**City of Yelm Staff Report**  
**2021.0026 Vista at Mill Pond Preliminary Subdivision**  
**Public Hearing - August 3, 2021, 10 AM**  
**List of Exhibits**

**HEARING EXAMINER STAFF REPORT**

Case Number: 2021.0026  
Applicant: AHBL, Inc  
Sheri Greene  
2215 North 30<sup>th</sup> Street #300  
Tacoma, WA 98403  
Request: Subdivide 7.22 acres into 29 single family residential lots  
Public Hearing Date: August 3, 2021  
Recommendation: Approval with conditions

# THE VISTA AT MILL POND

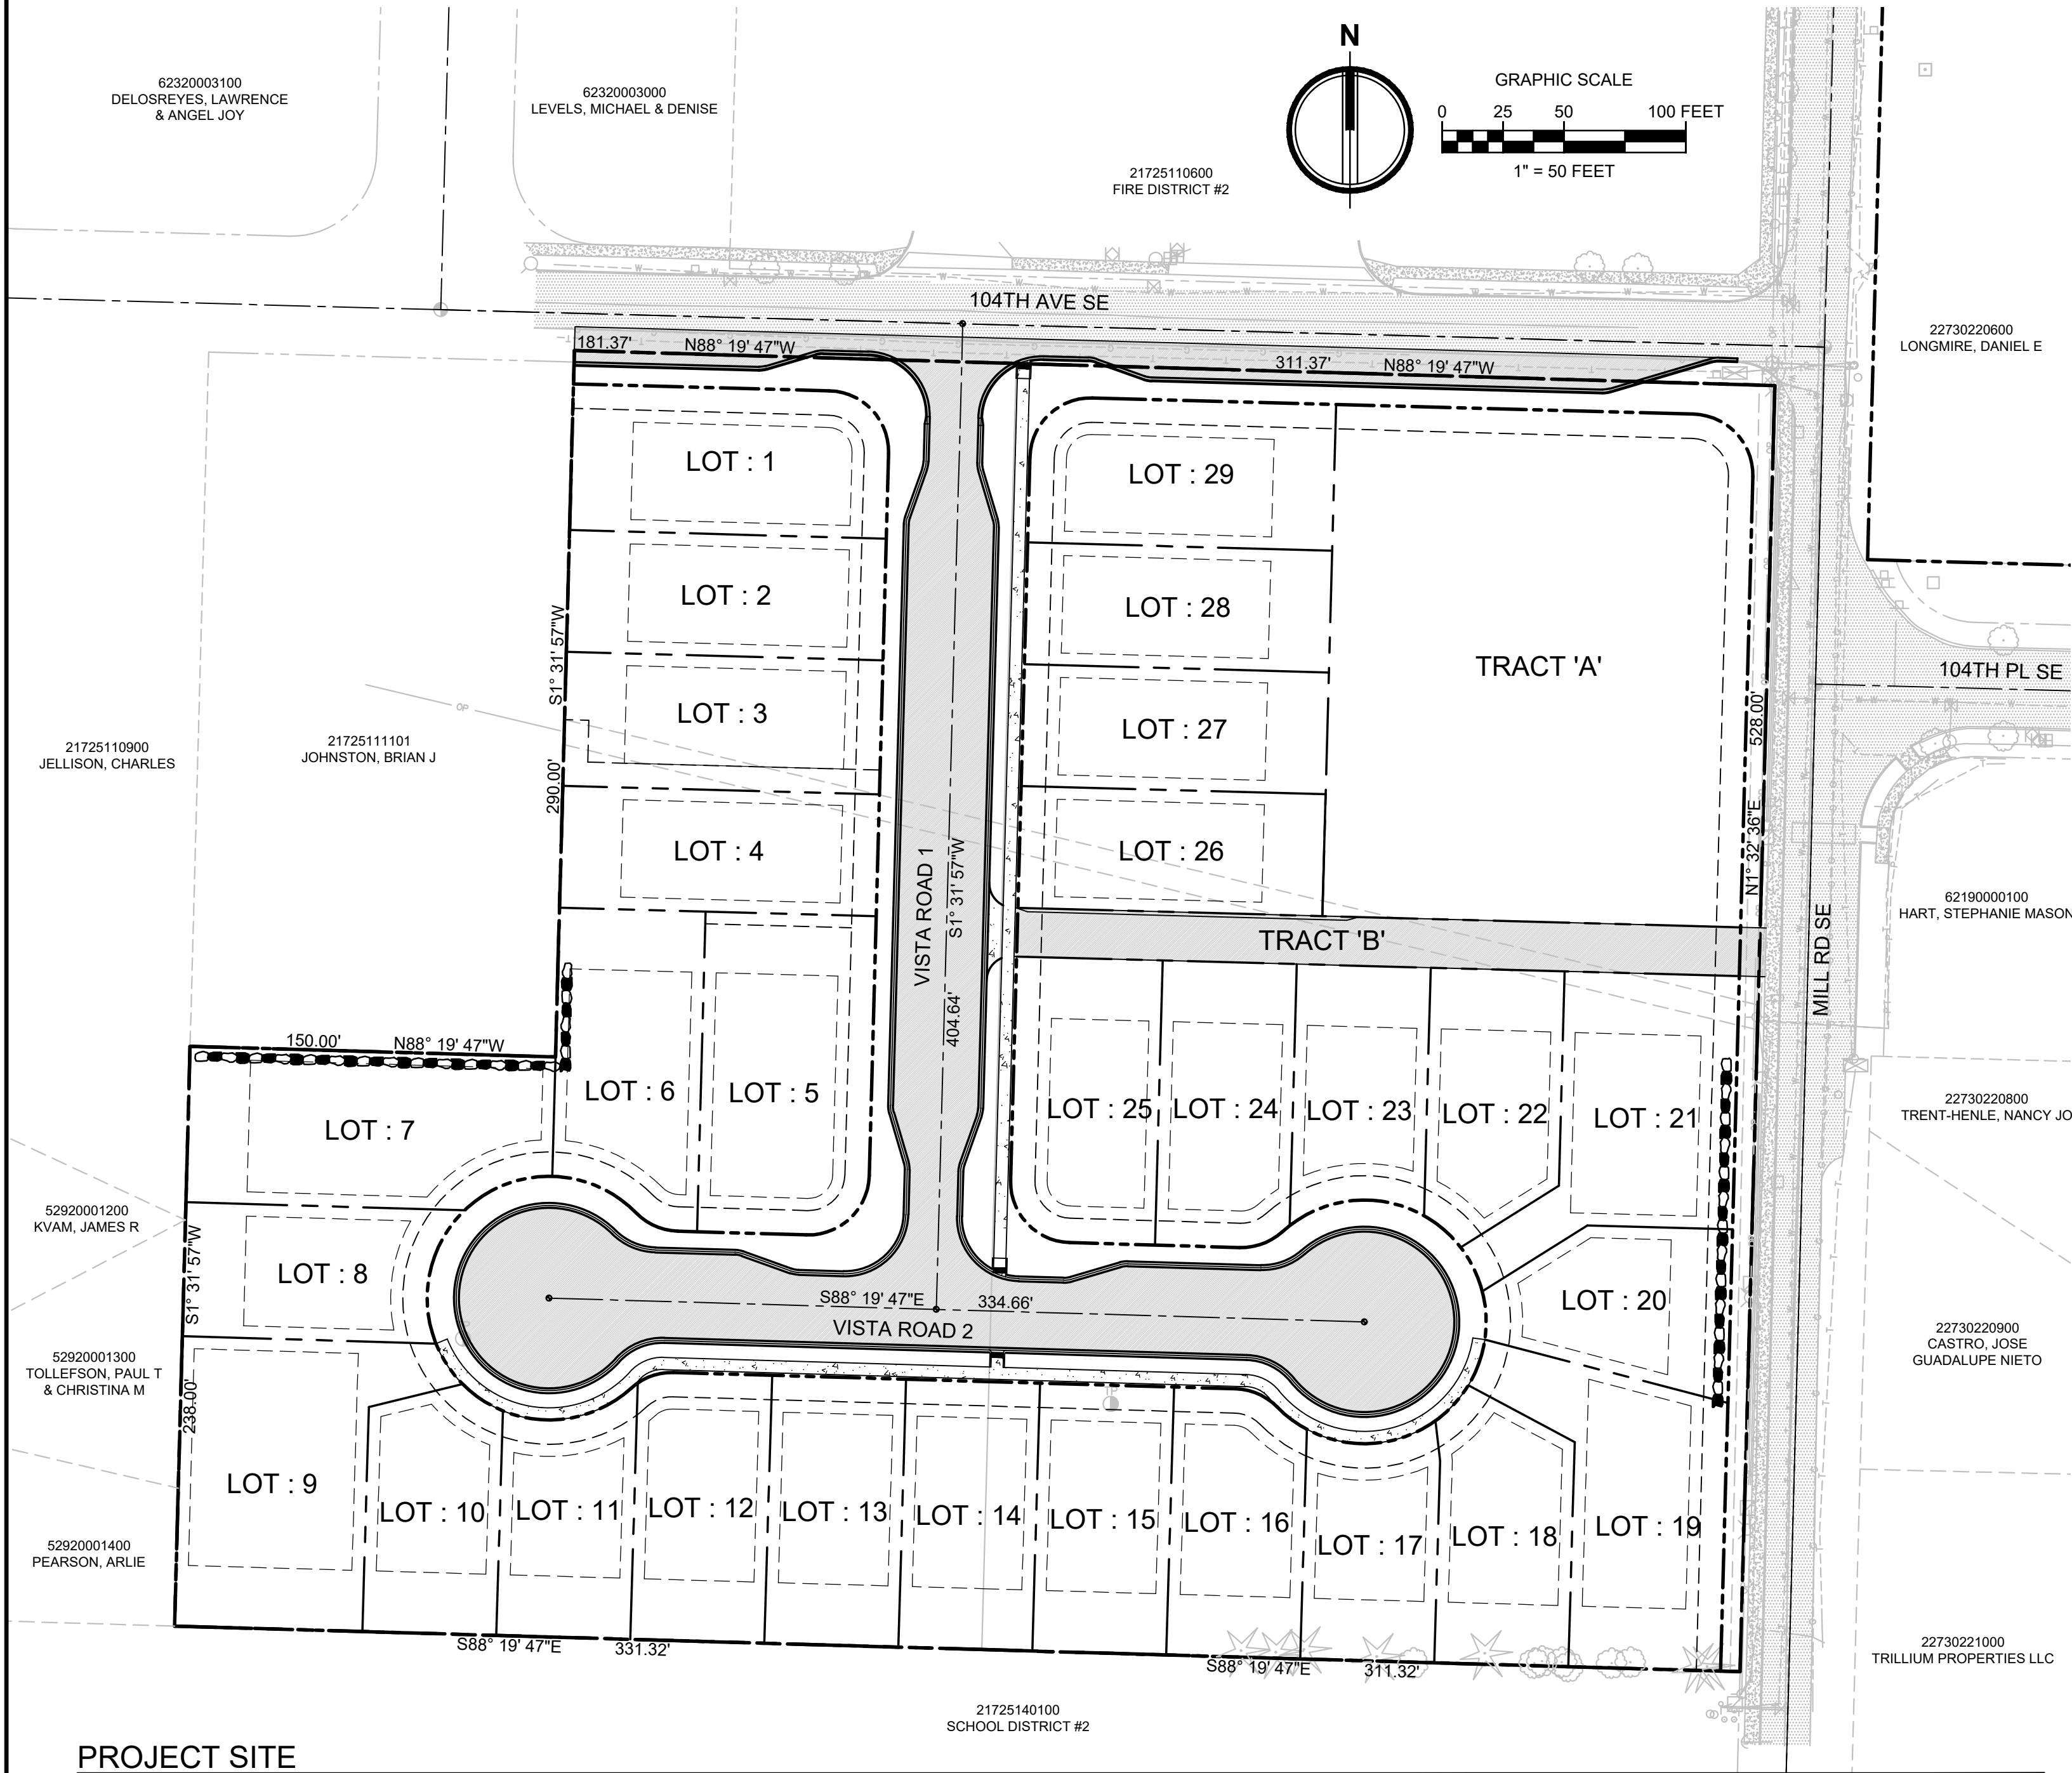
The storm treatment area is included in Tract A, which also serves as proposed open space. A perimeter landscape or other onsite landscaping theme should be incorporated. The preliminary landscape plan does not adequately address stormwater facility landscaping.

Section 18.56.010 YMC requires residential developments to include equal to or greater than five percent of the gross area of the development as qualified open space. The applicant has provided a preliminary landscape plan that shows 0.59 acres as open space in Tract A, which is approximately 8.19% of the gross project area. Sidewalk connections for internal pathways are required. The final landscape plan shall show recreation/open space uses on Tract A pursuant to Section 18.56.020 YMC. Active recreation could be achieved through park or play equipment.

13. Any onsite septic systems shall be abandoned per the Thurston County Health Department standards.
14. A final landscape plan must be submitted at civil plan submission showing perimeter, streetscape, and stormwater facility landscaping in compliance with Chapter 18.55 YMC.

16. The final landscape plan shall show recreation/open space uses on Tract A pursuant to Section 18.56.020 YMC.
17. Trees with a diameter exceeding 8 inches must be replaced at a 1:1 basis if removed.
